UNITED STATES
NUCLEAR REGULATORY COMMISSION
WASHINGTON, D. C. 20555

SAFETY EVALUATION BY THE OFFICE OF NUCLEAR REACTOR REGULATION
RELATED TO AMENDMENT NO. 87 TO FACILITY OPERATING LICENSE NO. DPR-23
CAROLINA POWER AND LIGHT COMPANY
H. B. ROBINSON STEAM ELECTRIC PLANT, UNIT NO. 2
DOCKET NO. 50-261

Time (s)
H.B.ROBINSON CYCLE 10 RELOAD
STEAM LINE BREAK ANALYSIS
BREAK DOWNSTREAM OF FLOW RESTRICTORS
FIGURE A-14

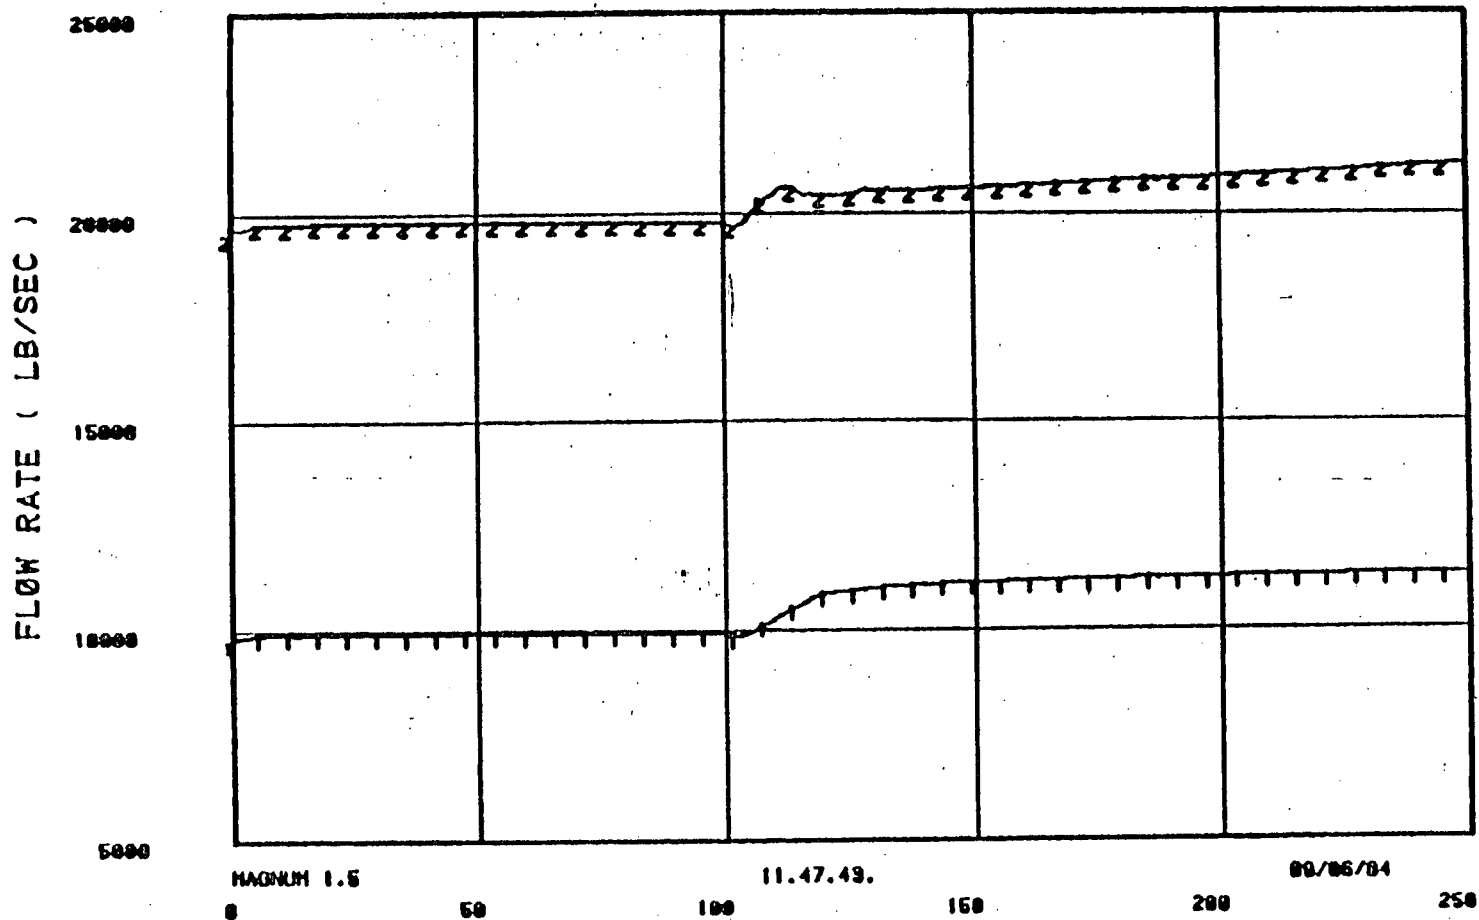
the energy generated by the core. The addition of borated ECC water assures a steady decline in reactor power. As the primary system coolant temperature is decreased, the primary system flow increases. This is in response to the increasing density. Figure A-14 shows that primary system flow as a function of time.

FIGURE A-15

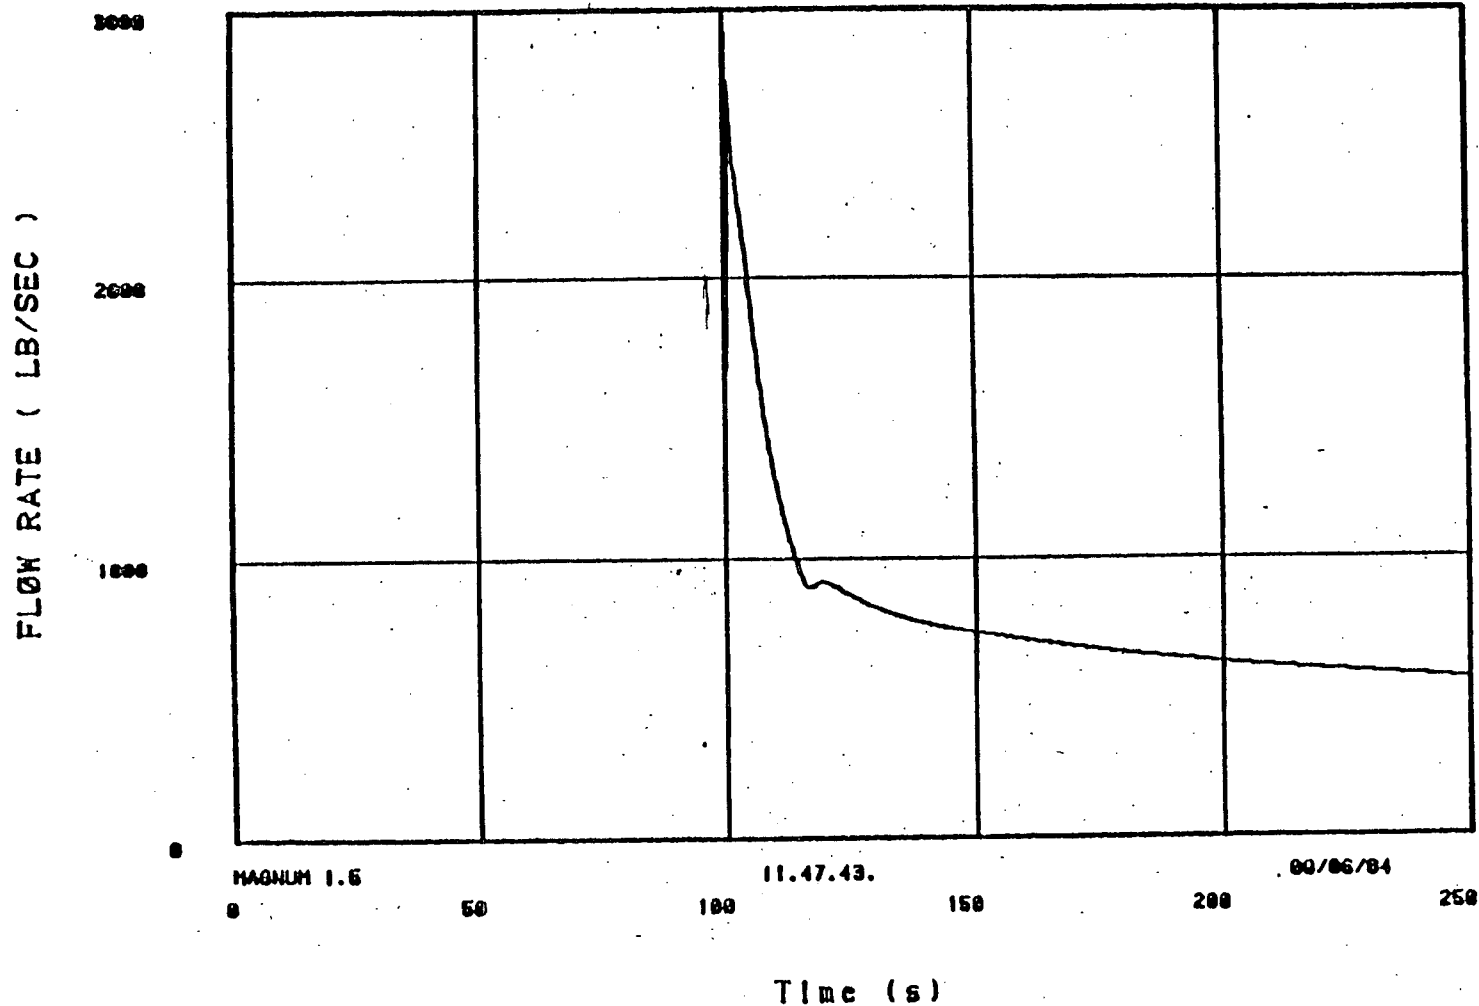
Figure A-15 and A-16 describe the break flow characteristics for the affected and intact steam generators, respectively. The blowdown of the steam generators is the primary forcing function for the SLB transient. At 150 seconds into the event (250 seconds of plot time), the break flow from the affected steam generator decreased to 577 lbm/sec. This is equivalent to the 20% of rated steam flow. The rapid isolation of the intact steam generators result from closure of the MSIVs.
